R09PE

**SUBJECT: RECALL R09PE VANDAL LOCK STARTER INHIBIT
NONCOMPLIANCE**

Vandal Lock Starter Wiring

MODELS AFFECTED: 2003-2010 All American Rear Engine models with Vandal Lock Options

Screw
Behind Driver's Side Front Access Panel

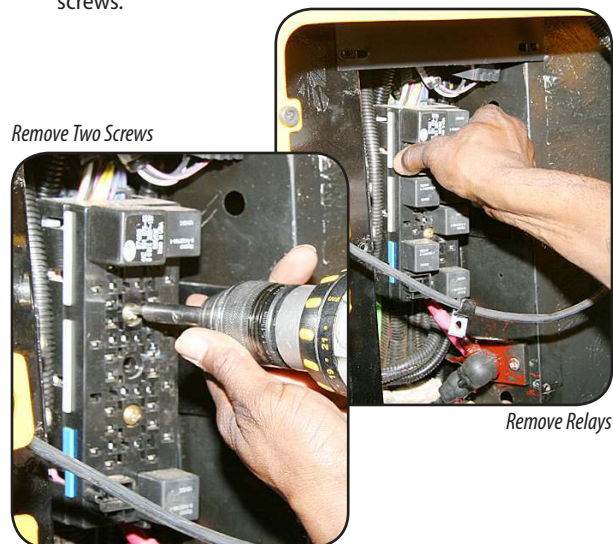
3.1 Remove six fasteners securing the windshield washer hose and the interior access panel.

3.2 Pull out and press down the interior access panel exposing the Master Chassis Harness Relay Box. *Note: Panel may be completely removed by removing center screw in lower flange.*

3.3 Note the relay positions. *Note: Reference decal on back of access panel moved in previous step.* Remove relays to access two screws that secure the relay box. Remove the screws.

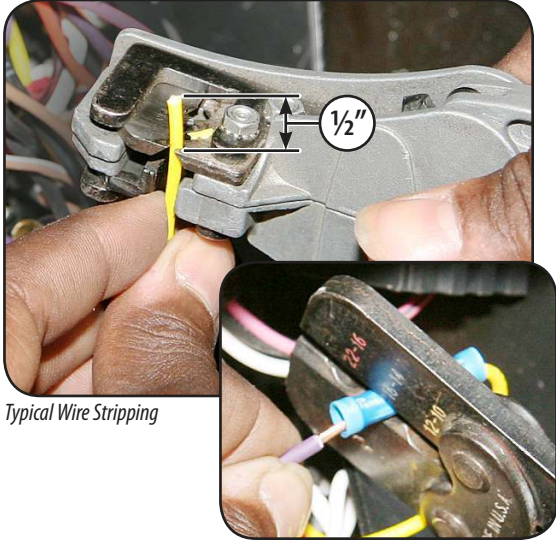
3.4 Pull the relay box forward, turn it around to access the rear cover. Remove the cover by pushing in the gray locking tabs located on both sides of the box.

3.5 Locate 16 gauge purple wire **1008**, that runs to the IGN dropout relay (4th down on left). Cut wire **1008** and tape the stub wire at the relay.

3.6 Locate 18 gauge yellow wire **1009**, that runs to the Vandal Lock Relay (5th down on right). Cut wire **1009** about 4 inches back from the relay.

Typical Wire Splicing

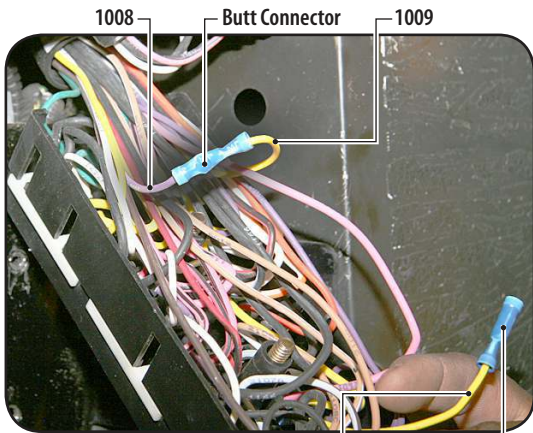
3.7 Strip the purple wire 1008 and yellow wire 1009 from the main harness 1/2 inch from the ends. Splice wires together using butt connector provided (BB #00036507).

4" Yellow Wire from Vandal Lock Relay
Splice to new loomed wire provided.

3.8 Strip the 16 gauge loomed wire provided (BB #01871300) and the 4 inch yellow 18 gauge wire coming from the Vandal Lock Relay (referenced in step 3.6) 1/2 inch from the ends. Splice wires together using butt connector provided (BB #00036507).

Wiring Access to Chassis

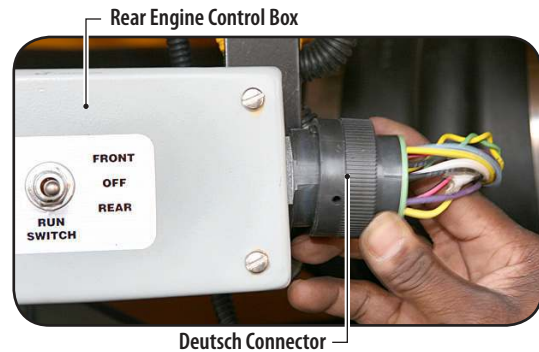
3.9 Pry back insulation material below relay box to create an access to the chassis for routing free end of 14 gauge loomed wire to the rear of the bus.

3.10 Insert free end of loomed wire thru the access created in step 3.9 and feed through the remaining wire.

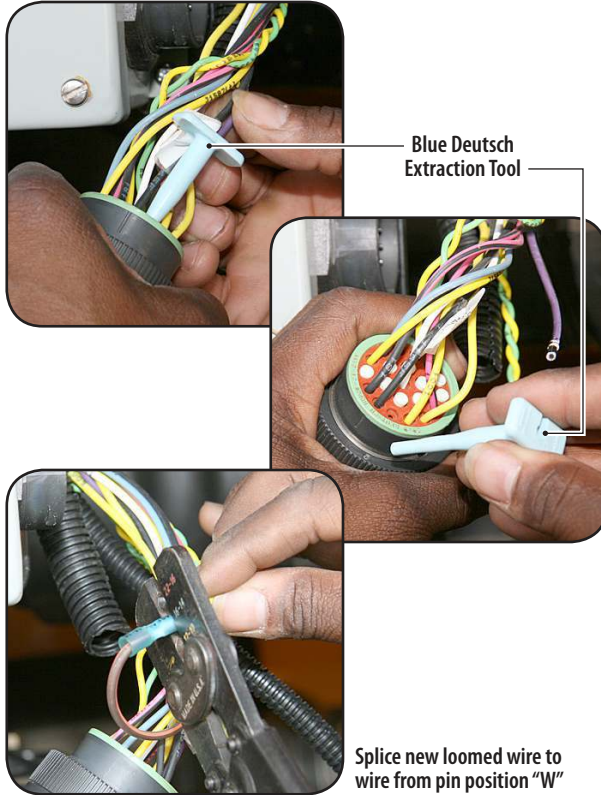
5.1 Remove Deutsch connector from the Rear Engine Control Box. Locate pin positions "X" and "W".

5.2 Remove the wire in pin position "W" using blue Deutsch extraction tool provided with parts. Cut off the terminal and strip wire 1/2 inch from the end. Splice to the new wire that was run through the chassis, using butt connector provided (BB #00036507).

5.3 Remove the wire in pin position "X" and place in pin position "W".
